Fire Department comments- revised 2/14/2022

Leland House proposal
21 Newton Street
Waltham, MA 02453

Fire Department comments

RE: 21 Newton Street, 40B Comprehensive Permit Application
Response to Fire Department

PROJECT: L-701

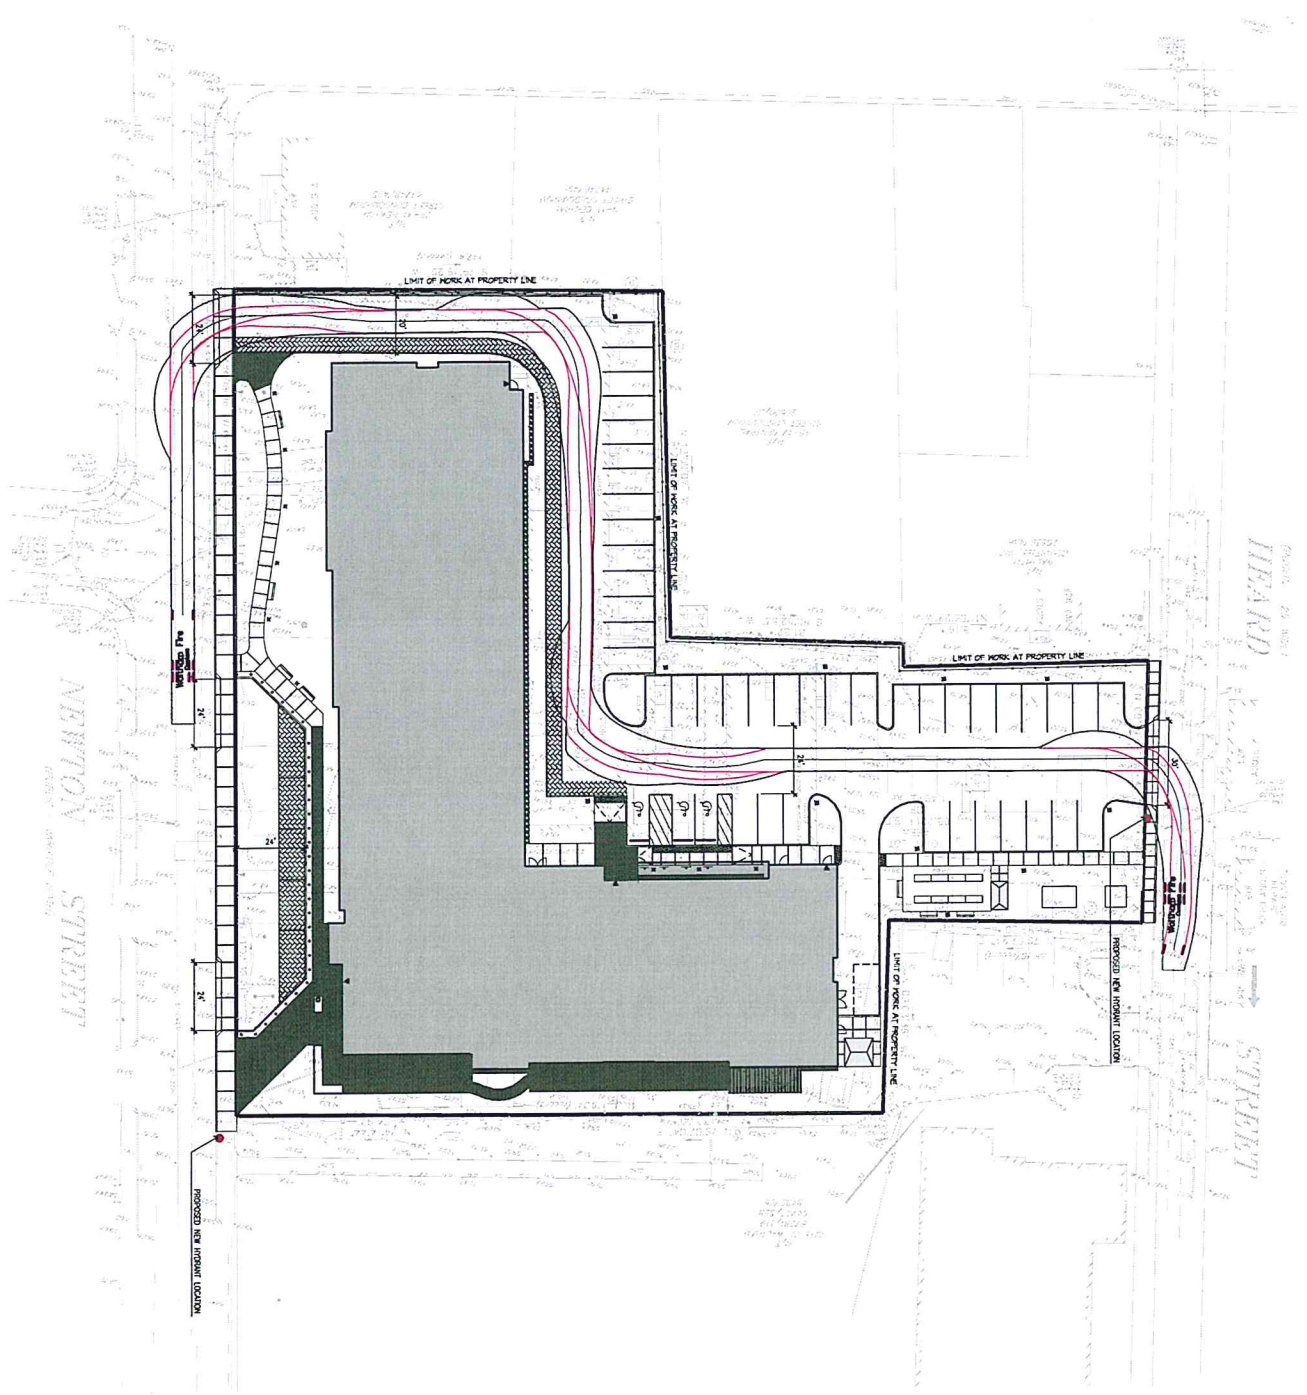
- Front of building on Newton Street side- enlarge curb cuts from 20' to 24' to allow fire apparatus and/or ambulance to pull into driveway and avoid blocking traffic on Newton Street.

- Front driveway- enlarge width of front driveway from 19' to 24' to allow fire apparatus and/or ambulance to bypass each other and/or civilian parked vehicles.

- Rear entrance off Heard Street- enlarge curb cut from 24' to 30' to allow fire apparatus to enter the rear lot.
- Heard Street water supply- Add a fire hydrant near the rear entrance on Heard Street. The closest hydrant is on opposite side of Main Street or at Central Street/Cross Street.

- Rear driveway- enlarge width of parking area from 20' to 24' wide to allow apparatus to bypass each other if necessary.
- Rear Driveway- provide turnaround for fire apparatus in rear lot or continue fire access road around to connect with Newton Street on left side of building (B Side).

*Agreed. The two (2) curb cuts on Newton Street shall be enlarged to 24' on the Revised Plans to be filed with the Zoning Board of Appeals (ZBA) at a later date and as shown on the attached **Exhibit A - Fire Access Plan**.*

*Agreed. The width of the front driveway off of Newton Street shall be enlarged to 24' on the Revised Plans to be filed with the ZBA at a later date (see also **Exhibit A - Fire Access Plan**).*

*Agreed. The width of the Heard Street curb cut shall be enlarged to 30' on the Revised Plans to be filed with the ZBA at a later date (see also **Exhibit A - Fire Access Plan**). Further, the Petitioner shall modify its list of waivers to include a waiver from § 5.41 of the Zoning Ordinance with regard to a driveway opening exceeding 25'.*

Agreed. The Revised Plans to be filed with the ZBA at a later date shall include a fire hydrant on Heard St. near the entrance to the rear parking lot.

*Agreed., The Heard Street driveway shall be enlarged to 24' on the Revised Plans to be filed with the ZBA at a later date (see also **Exhibit A – Fire Access Plan**).*

*Agreed. The rear parking lot has been redesigned to allow fire apparatus to reach the southerly wing of the building and then turn around in the rear lot by backing into the loading area, as can be seen on **Exhibit A**. Stantec is in continued discussions with the fire department to review the updated fire access plan and swept path analysis in person. However, it should be noted that creating a connection from the rear lot to Newton Street on the south side of the building would require a significant redesign of the building and site, loss of a number of housing units and parking spaces. The Leland House building was located in the best location on the site from an engineering and architectural perspective and based on an extensive community process with the Ward Councilor, neighbors and abutters that resulted in a significant reduction in size from the initial proposal before the Community Preservation Committee and the City Council. Redesign of the building included reduction of the building size from 79 units to 68 units, lowered height from 4 stories to 3 stories, and an increase in the parking ratio from 40 spaces (0.5 ration) to 51 spaces (0.75). Further redesign of the building at this stage resulting in a loss of units could jeopardize the Petitioner's funding application with the Department of Housing and Community Development as part of its annual funding competition for affordable housing developments.*
